Addendum No.2
to
CONSTRUCTION DOCUMENTS
for

June 2, 2025
2023159.00

NCISD New District Administration Building
21330 Valley Ranch Parkway
New Caney, TX. 77357
June 2, 2025

T-103-A1

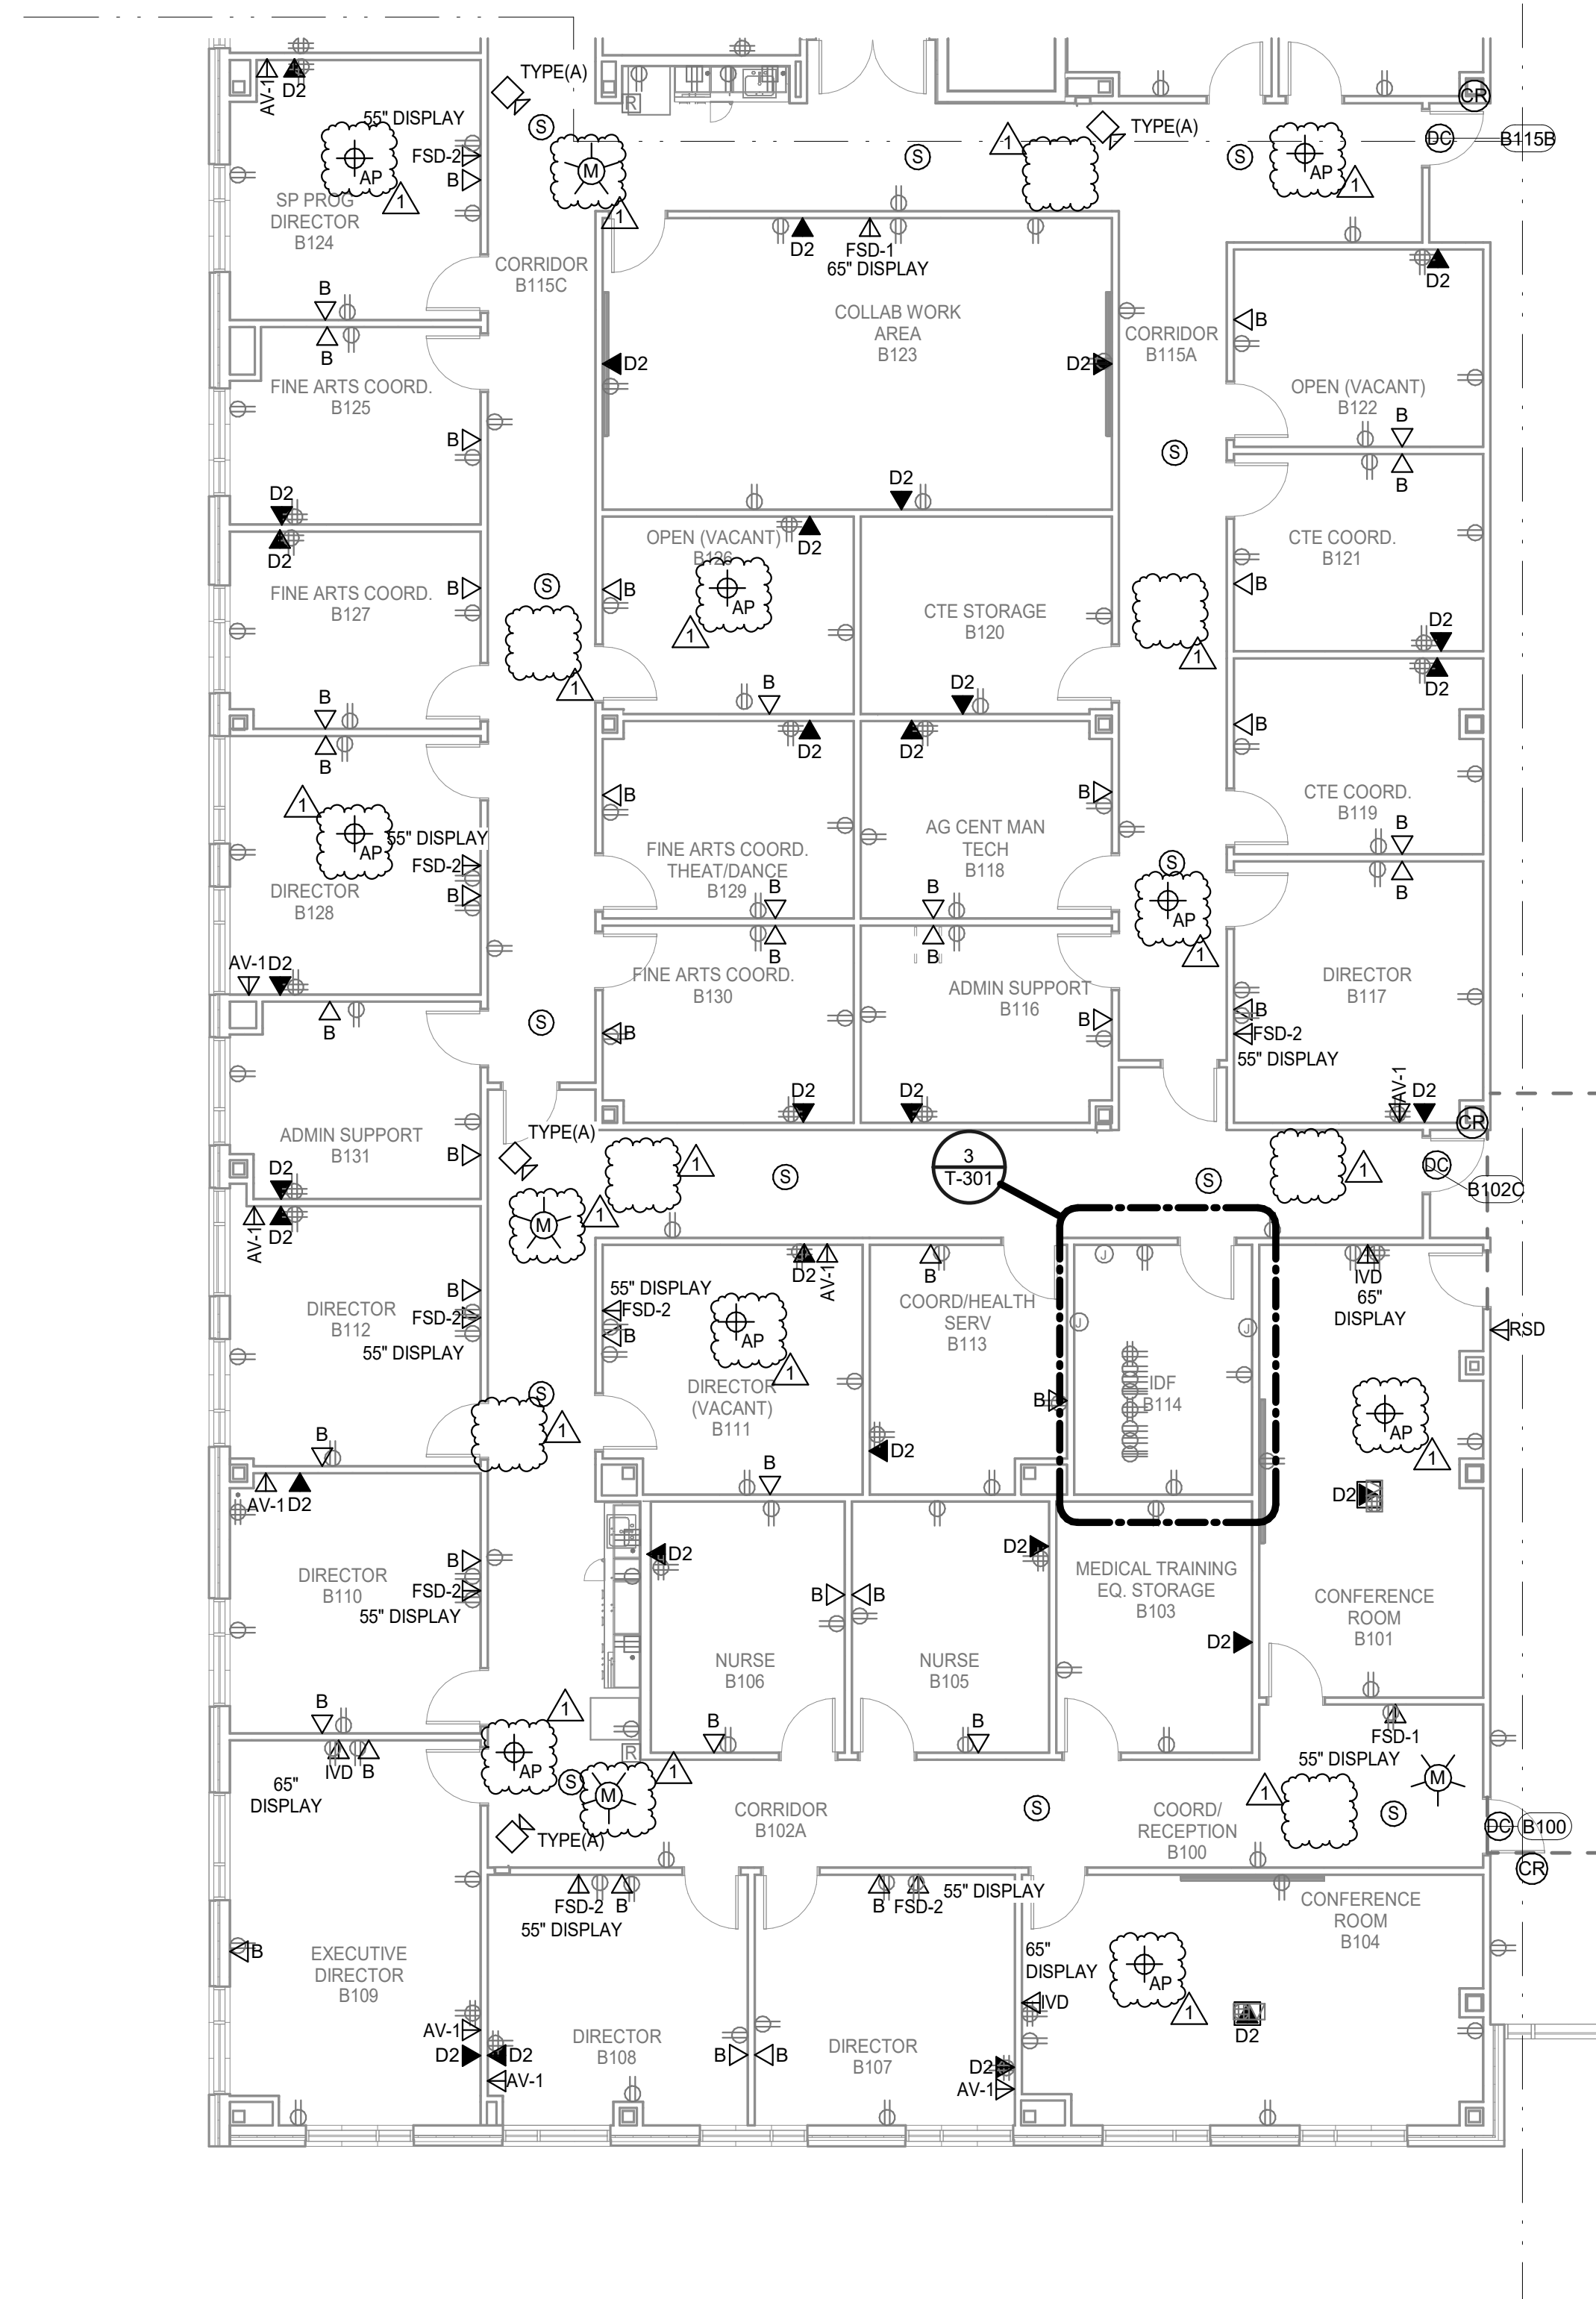
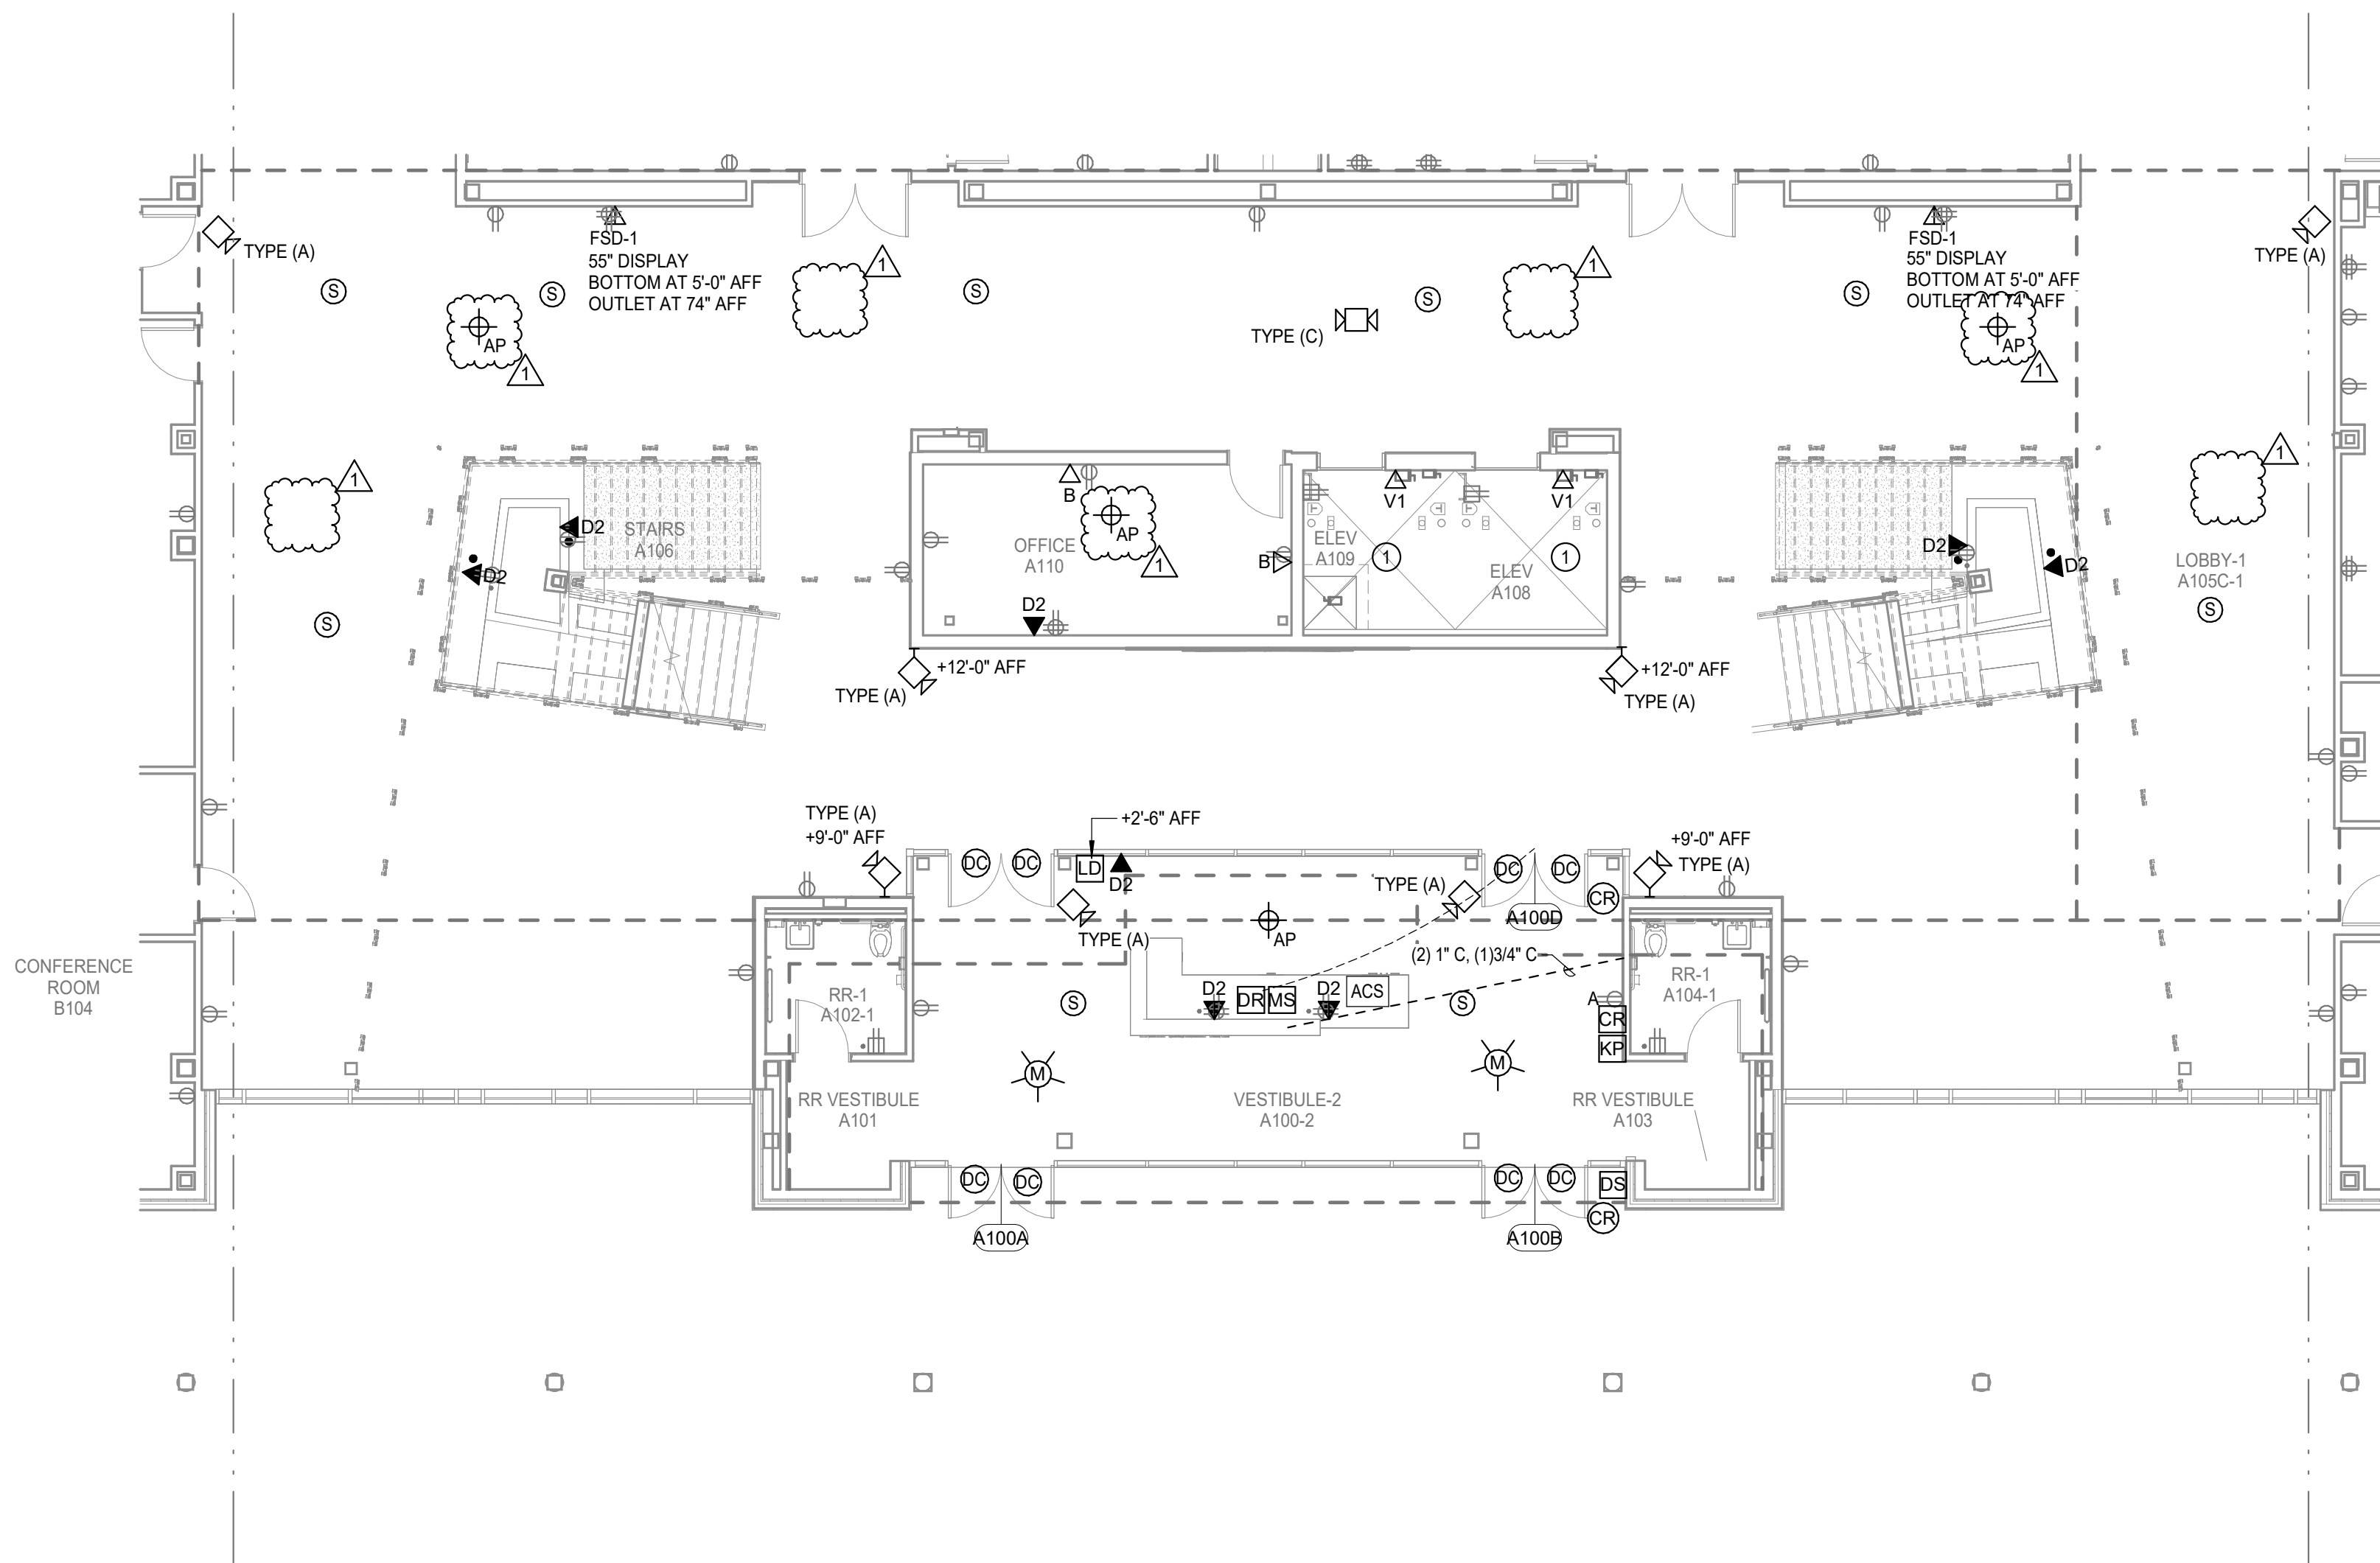
- a. Revised clouded camera type.
 - b. Revised clouded camera mounting note.
 - 12. SHEET T-103-A1 - TECHNOLOGY FIRST FLOOR AREA - A1
 - a. Revised wireless access point 'AP' layout as shown.
